**Origination Form**  
Proposed Revisions to a Standard Plans Index

<b>Originator:</b>	Turley, Joshua	<b>Index Number:</b>	700-020
<b>Date:</b>	5/14/2025	<b>Sheet Number(s):</b>	Sheet 1
<b>E-mail:</b>	Joshua.Turley@dot.state.fl.us	<b>Index Title:</b>	MULTI-COLUMN GROUND SIGN

MULTI-COLUMN GROUND SIGN

INDEX  
 700-020

SHEET  
 1 of 3

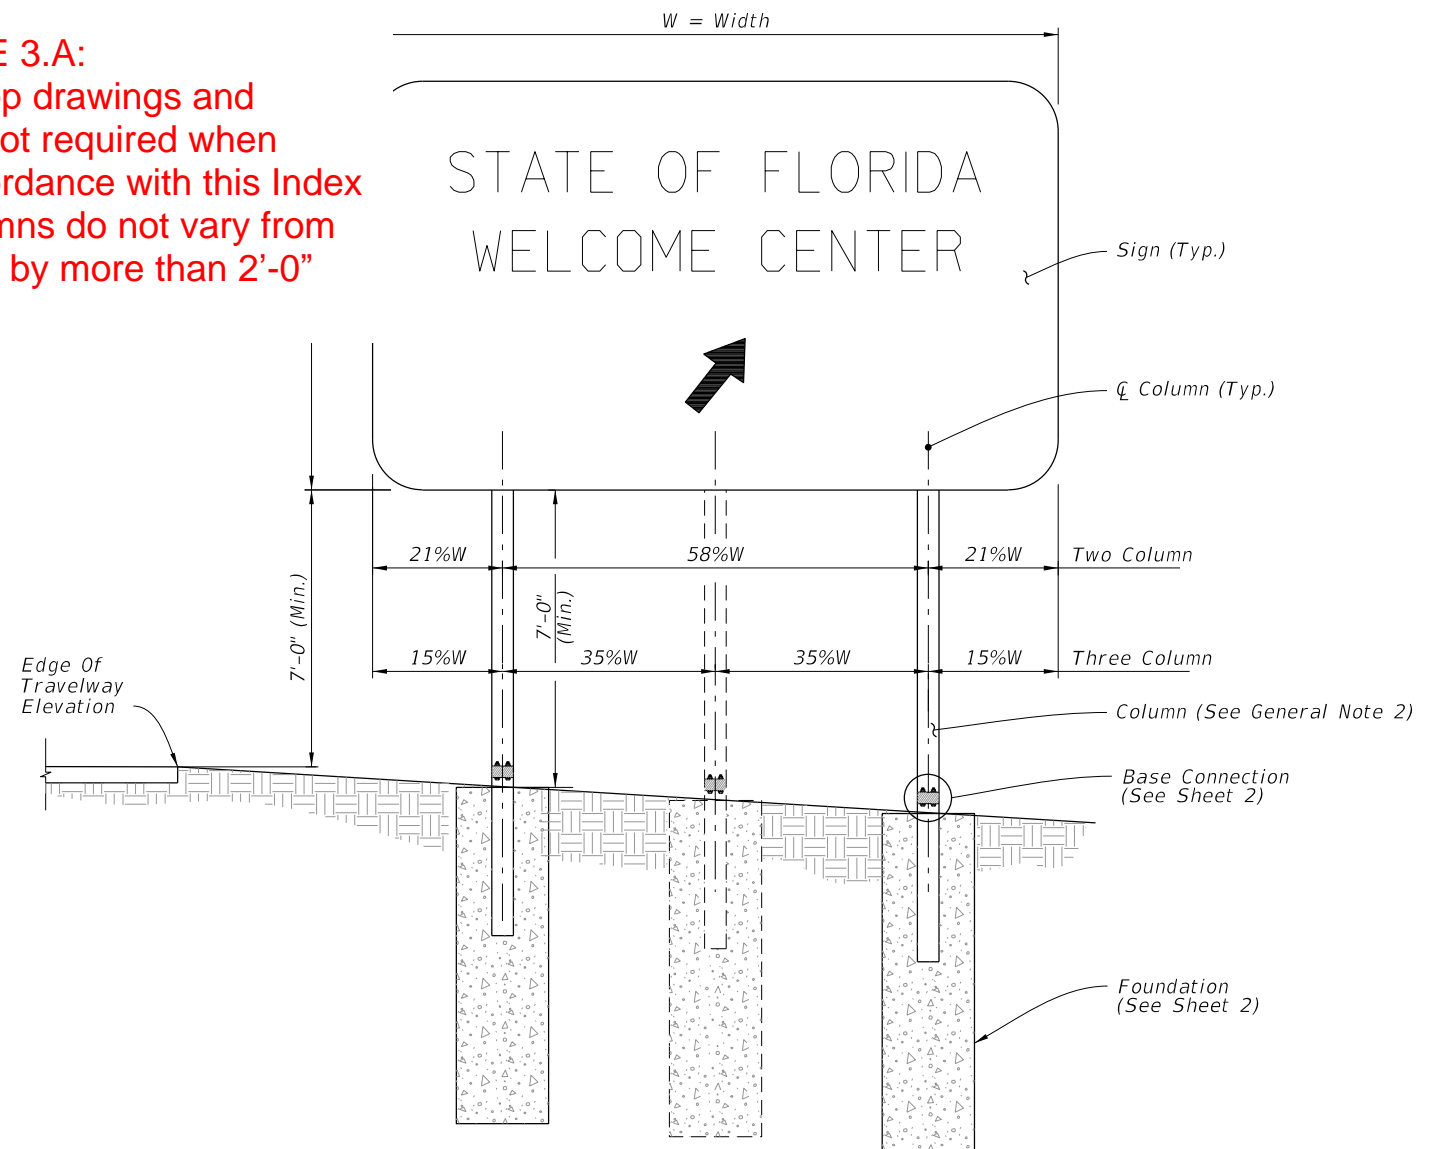
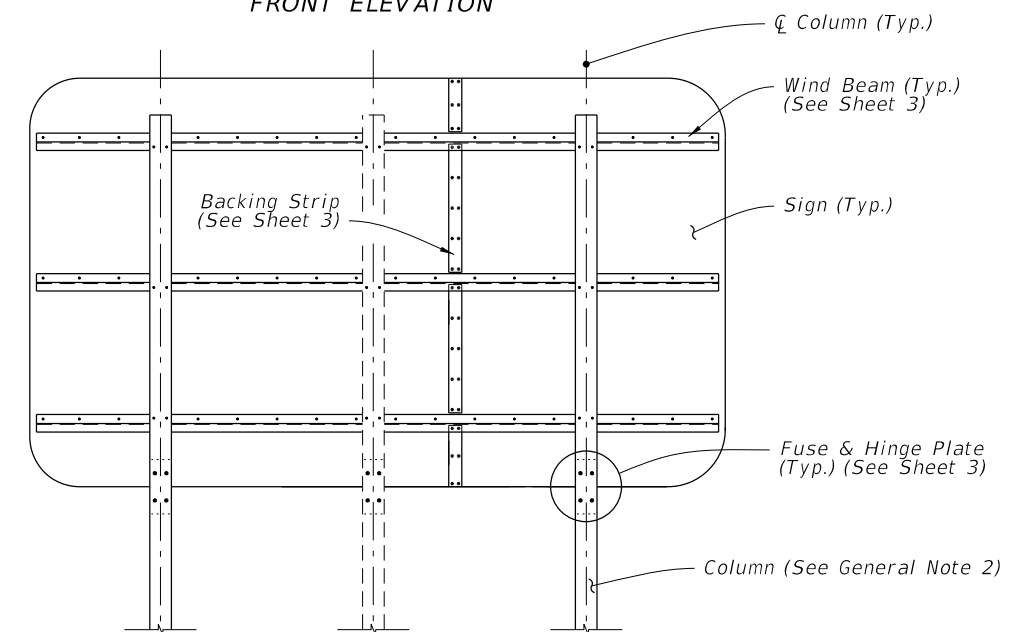
Sheet 1: Modified note 3A for clarity.

There was some confusion of what the 2'-0" allowance meant. It refers to the column locations not for anything in the index.

- ~~A. Sign Support Shop drawings are not required when fabricated in accordance with this Index and support columns do not exceed the width ("W") shown in the plans by more than 2'-0".~~
- B. Sign Panels: Horizontal panel splices are allowed at interior wind beams for sign panels with a height ("H") greater than 10 feet. Shop drawings required for horizontal panel splice details.
- C. When shop drawings are required, obtain approval prior to fabrication.

**CHANGED NOTE 3.A:**  
 Sign Support Shop drawings and calculations are not required when fabricated in accordance with this Index and support columns do not vary from the plan locations by more than 2'-0" longitudinally.
